BLUE BIRCH 1447 NW 65TH ST

DESIGN REVIEW BOARD MEETING
25 July 2022
SDCI Project #3036782-LU

SITE PLAN

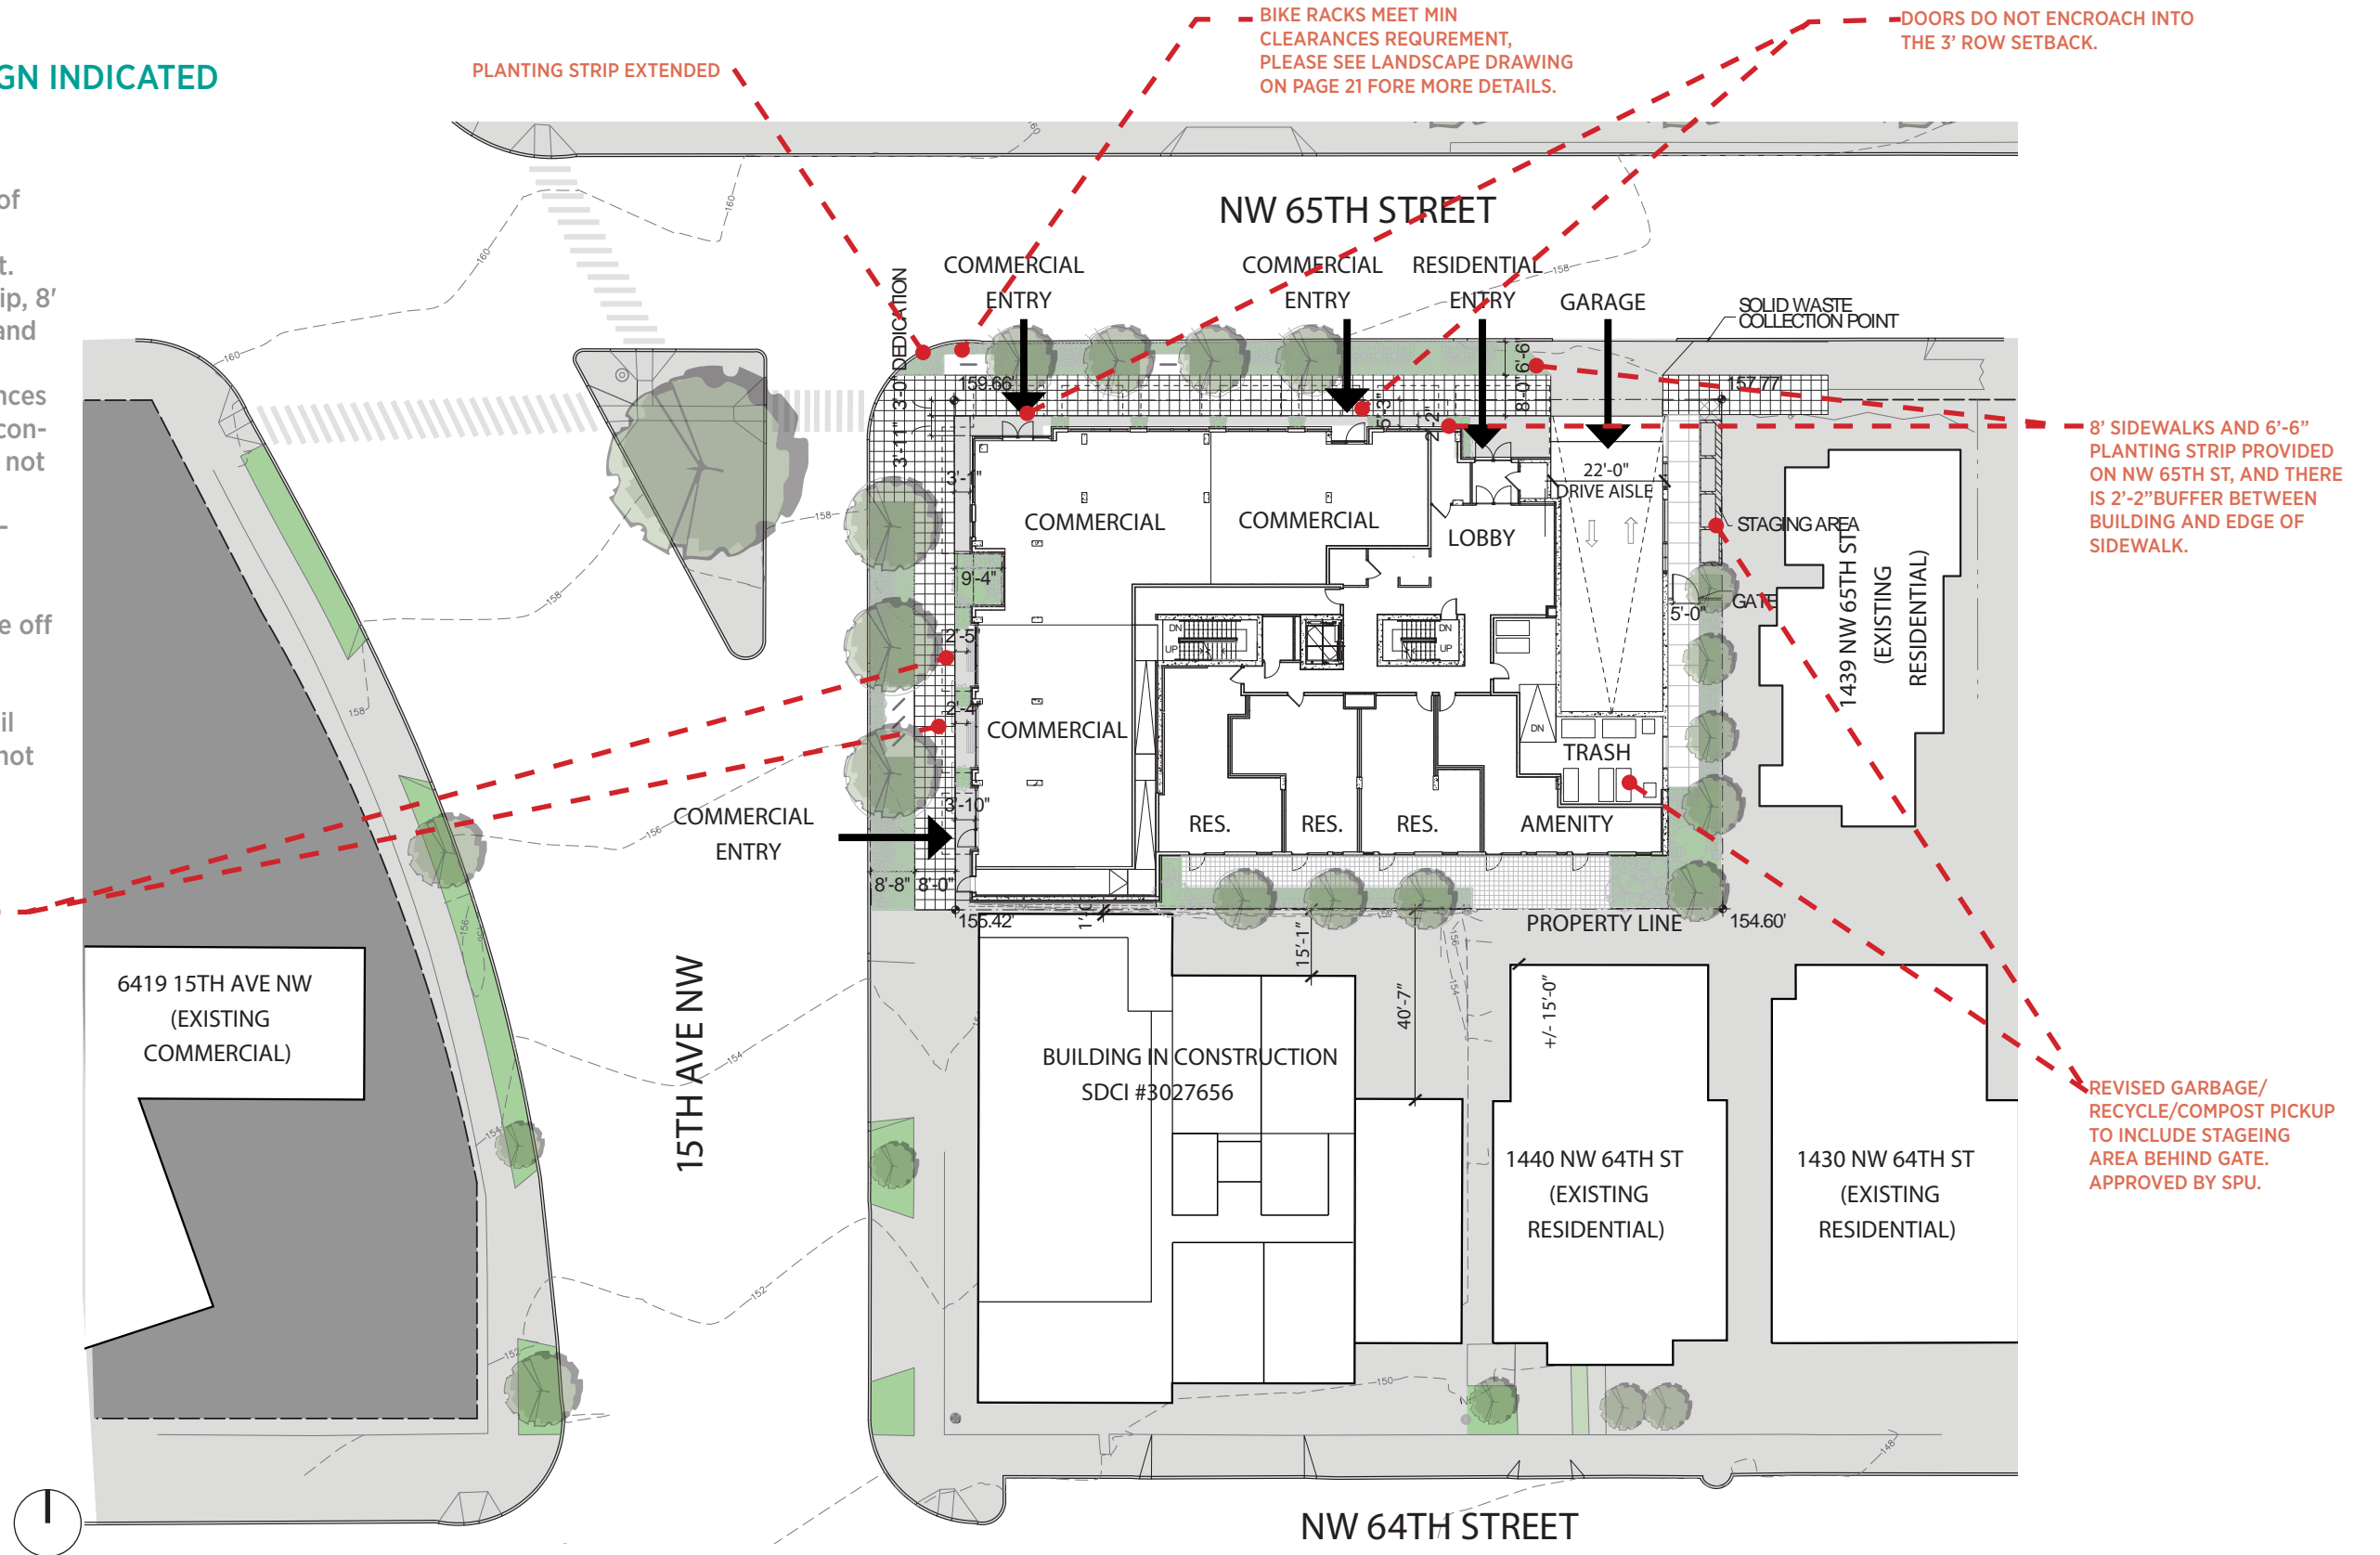
SDOT 60% SIP Comments

- 2' clearance needed between edge of bench and edge of sidewalk
- 8' sidewalks required on NW 65th St. Extend south leaving a 6' planting strip, 8' walk, and 1' buffer between building and edge of sidewalk.
- Confirm bike racks meet min clearances meet SDOT DR 01-2020 (pg 28) and confirm total foot print when in use does not encroach in the sidewalk.
- Doors cannot swing out into and encroach in the sidewalk, dedication, or ROW setback.
- Extend planting strip to 15th to close off 65th st crossing.
- There is an extra door shown on the landscape plans not shown on the civil at the east end of the building. It cannot swing into the 3' ROW dedication.

MORE THAN 2' CLEARANCE PROVIDED BETWEEN EDGE OF BENCH AND EDGE OF SIDEWALK.

ILLUMINATION PLAN - ROOF

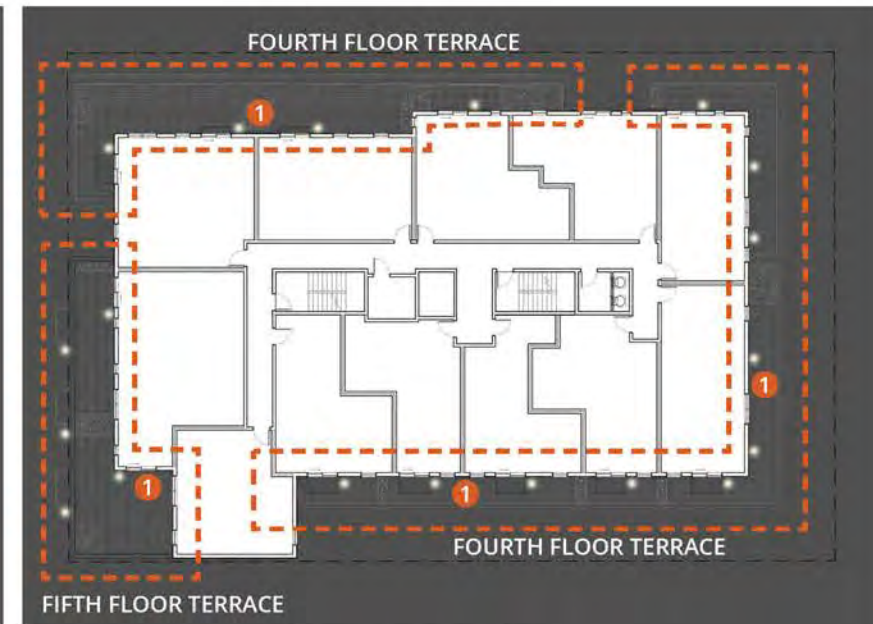
B. The Board recommended a condition to provide the lighting as shown in the Recommendation packet on page 35 of Appendix A, as shown above. (DC4-C)

B. The Lighting will be provided, see Lighting page 32.

CURRENT PERSPECTIVE VIEW

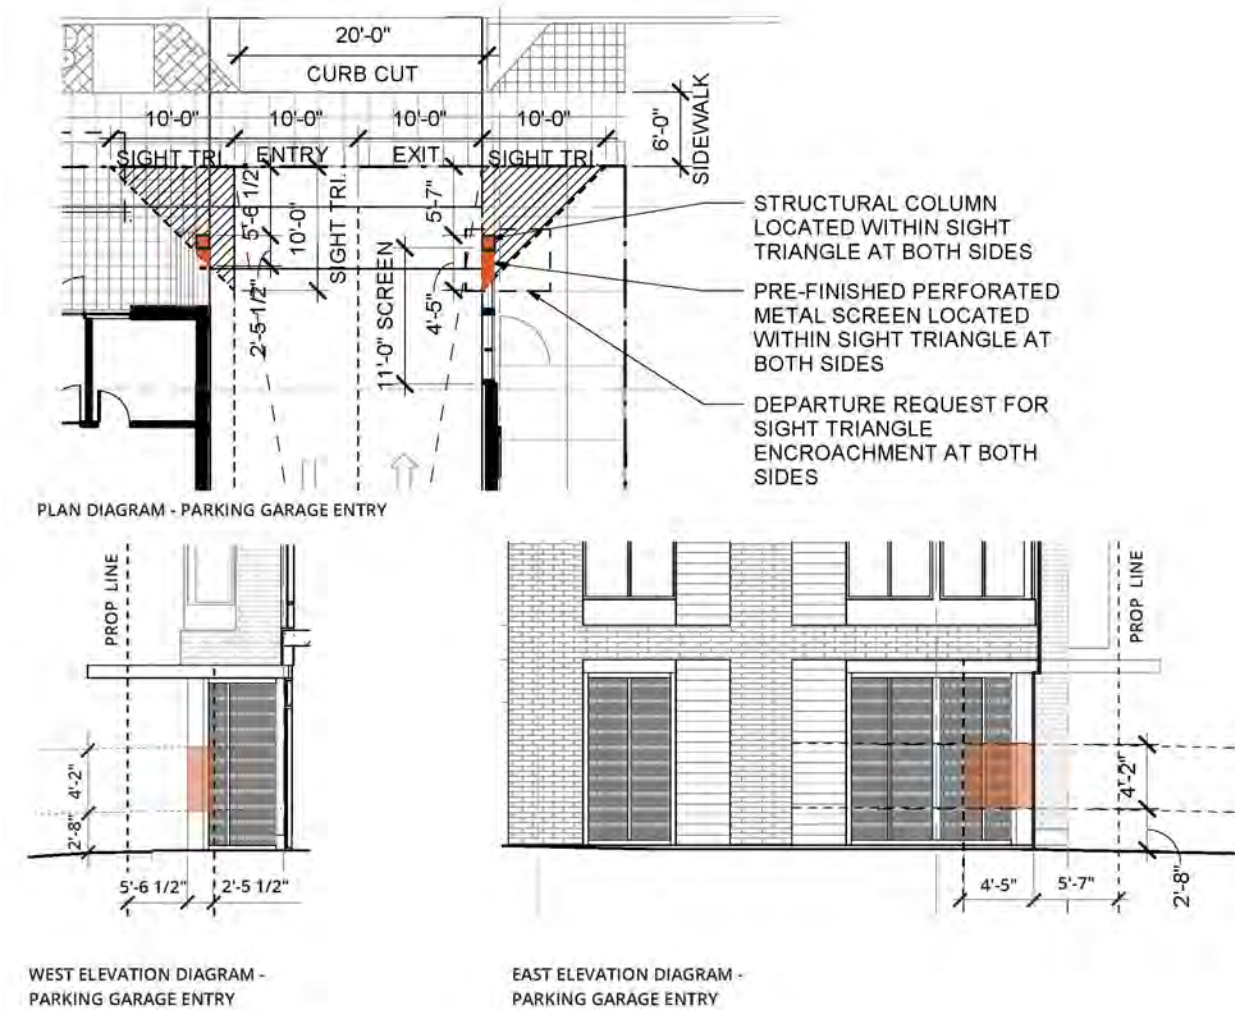
C. The Board recommended a condition to provide white vinyl window frames at the white Hardie facades. (DC2-B-1, DC4-A-1)

D. Consider having the solo balcony at the upper level along 15th Ave NW match the smaller balconies at the white upper level along NW 65th St. The Board declined to make this a condition of approval. (DC2-B-1, DC2-C-1)

E. Consider a solid parapet at the darker massing along 15th Ave NW to match the solid white parapet at the upper levels balanced against the parapet treatment at the brick massing as shown on page 15 of the Recommendation packet. The Board declined to make this a condition of approval. (DC2-B-1)

C. Vinyl window frames at the white Hardie panel facades are changed to white.

D. The balconies at upper floor are all changed to juliet balconies so they match each other.

E. The low parapets with metal railings are retained. Though they are different from the solid white parapet at the upper levels, the semitransparent railing will provide a better view for occupants. Also, since the parapet at brick massing is lower than those at darker massing, these two massings can be visually distinguished.

CURRENT DESIGN

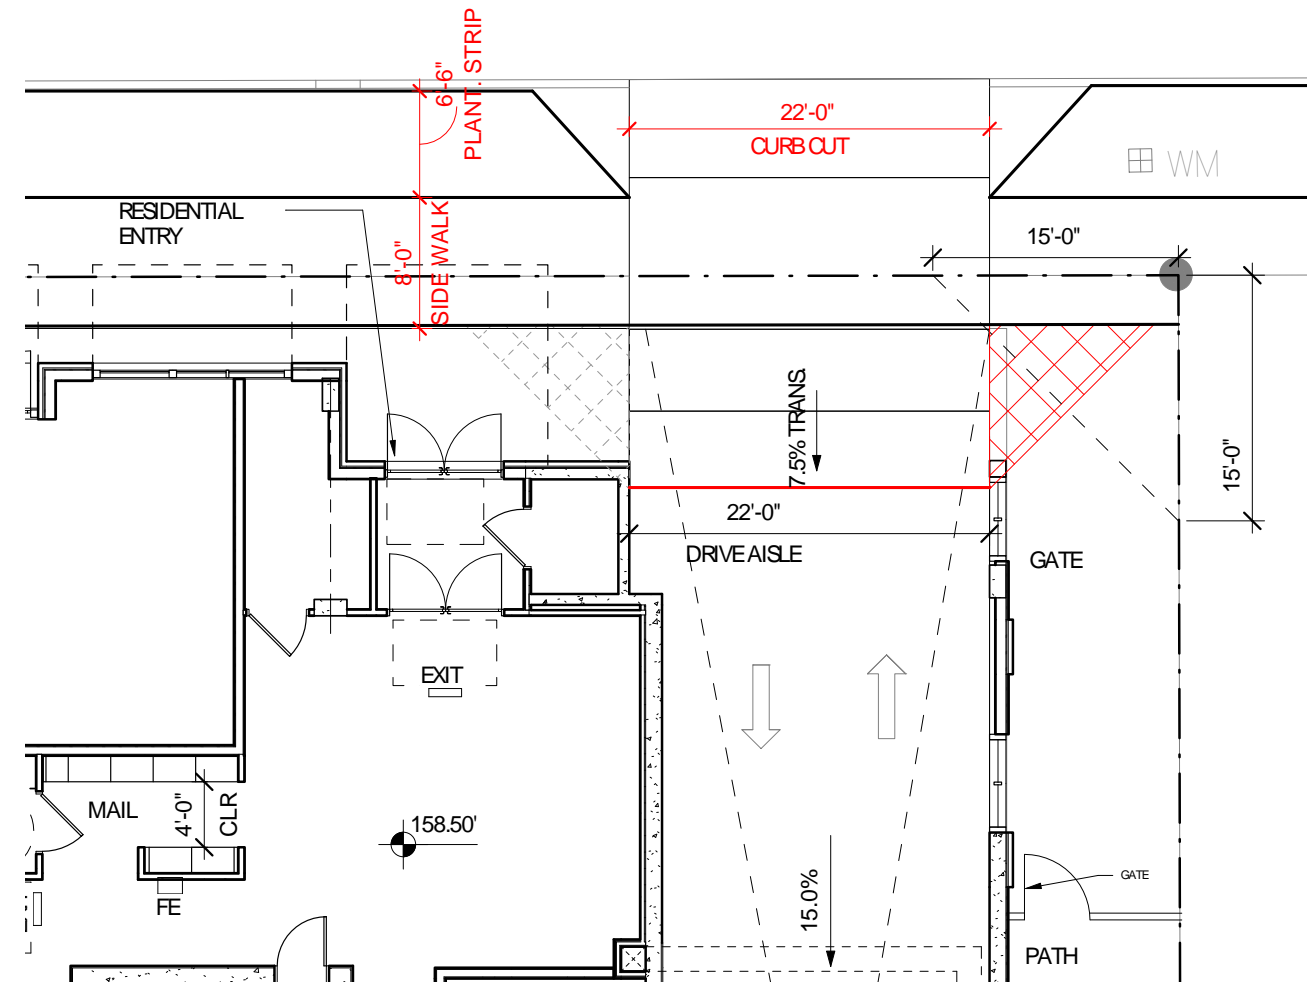
A. The Board recommended a condition to provide a 22' wide curb cut at the access along NW 65th St to below grade parking. Pull back the structure and other building elements as much as possible to be clear of the required sight triangle area. (PL2-B-1, DC1-B-1)

A. 22' wide curb cut provided and the structure was pulled back as much as possible. But in response to SDOT's SIP comments, the planting strip is 6' 6" wide (used to be 5' 6"), and the side walk is 8' 0" (used to be 6' 0"), There's a small portion of the building column intruding in the right sight triangle. Because of the 22' width, the left sight triangle is not required. Please see page 34, 35 for more details about departures.

PLAN DIAGRAM - CURB CUT ALONG NW 65TH ST

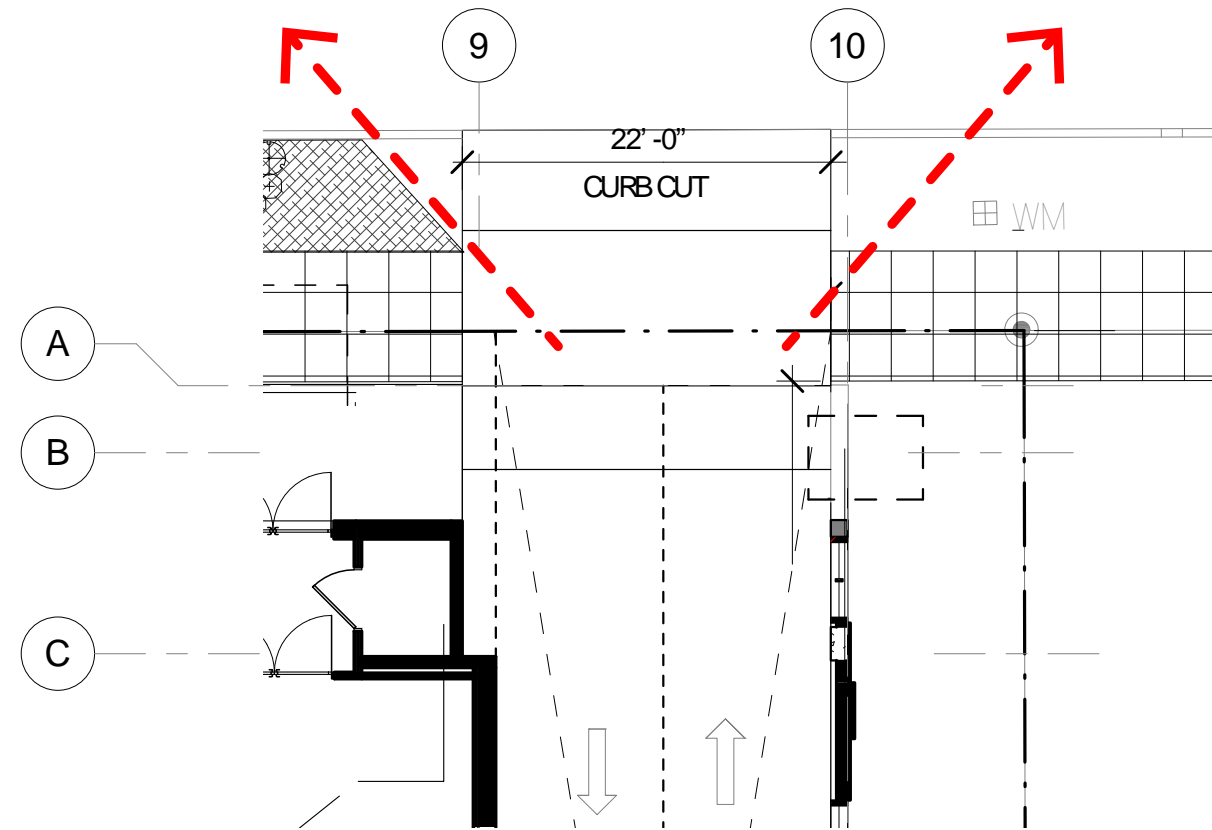
Curb Cut Width: The Code allows one curb cut greater than 10 feet, but in no case greater than 20 feet in width, may be substituted for each two curb cuts permitted by subsection 23.54.030.F.1.a.

PROPOSED
A 22-foot curb cut provided along NW 65th St.

JUSTIFICATION
This departure would provide wider curb cut and a wider line of sight for exiting vehicles.(PL2.B.1) It will help to minimize conflict between vehicles and pedestrians (many of them are Ballard High School students) on the sidewalk.(DC1.B.1)

PLAN DIAGRAM - PARKING GARAGE ENTRY

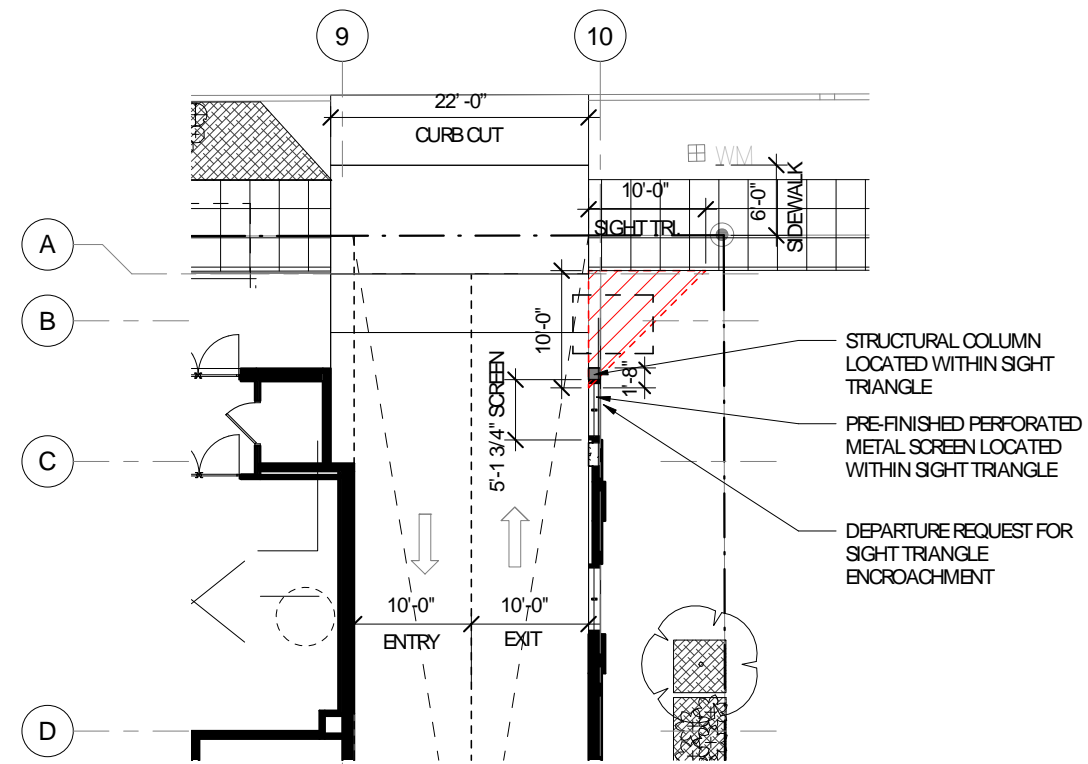
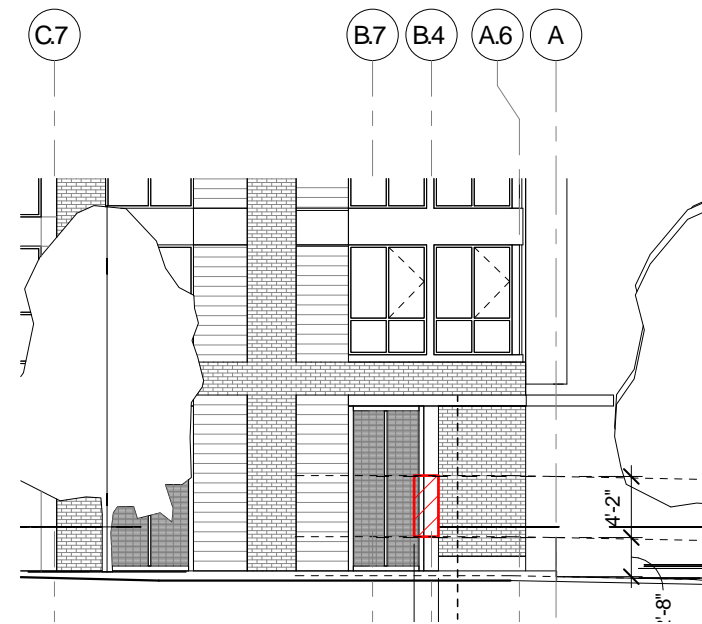
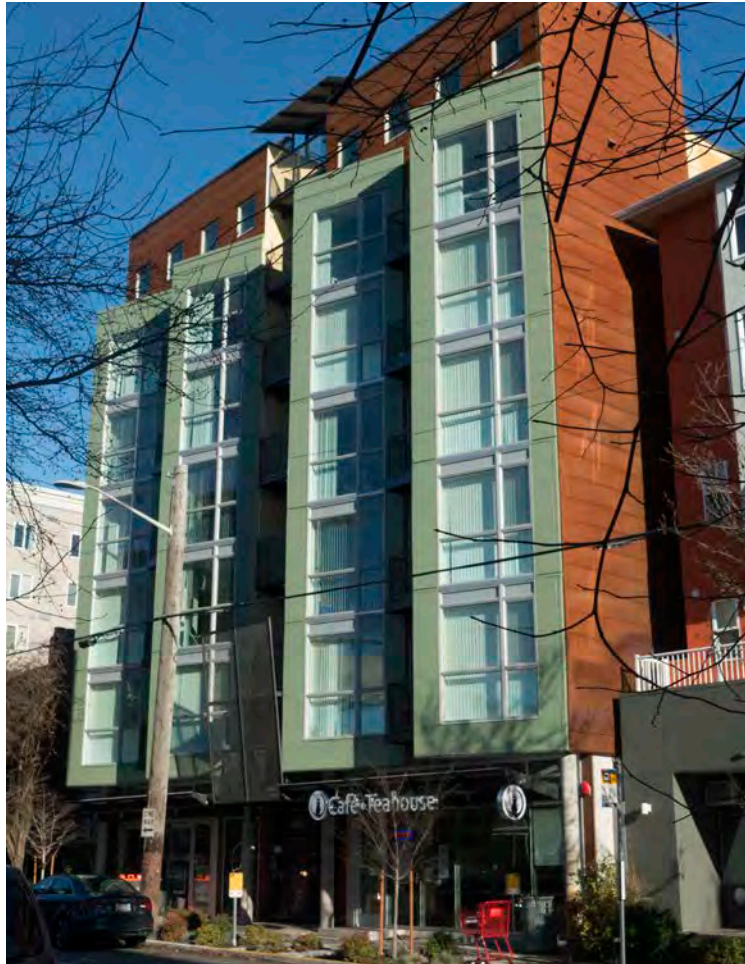
2. For two way driveways or easements 22 feet wide or more, a sight triangle on the side of the driveway used as an exit shall be provided, and shall be kept clear of any obstruction for a distance of 10 feet from the intersection of the driveway or easement with a driveway, easement, sidewalk, or curb intersection if there is no sidewalk. The entrance and exit lanes shall be clearly identified.

3. The sight triangle shall also be kept clear of obstructions in the vertical spaces between 32 inches and 82 inches from the ground.

To allow for a structural column and perforated metal screen on the exit side of the sight triangle. The encroachment is 1'-8" in the required sight triangle.

The proposed residential entry and drive aisle (22'-0" two-way) has been setback from the property line to provide sight triangle at the exit lane, which provide safe and convenient access point for all modes of travel. (PL4.A.1) It emphasizes the use of sidewalk for pedestrians and create safe condition for pedestrians and drivers. (DC1.B.1) Since the sidewalk and planting strip are widened, the structural support column required at the northeast corner to hold up the 2nd and 3rd floor massing encroaches into the sight triangle for 1'-8". But the perforated metal screen will provide added protection for pedestrian traffic while providing visual continuity for circulation. This makes a strong connection to the street and the building will interact well with the public realm.(CS2.B.2)
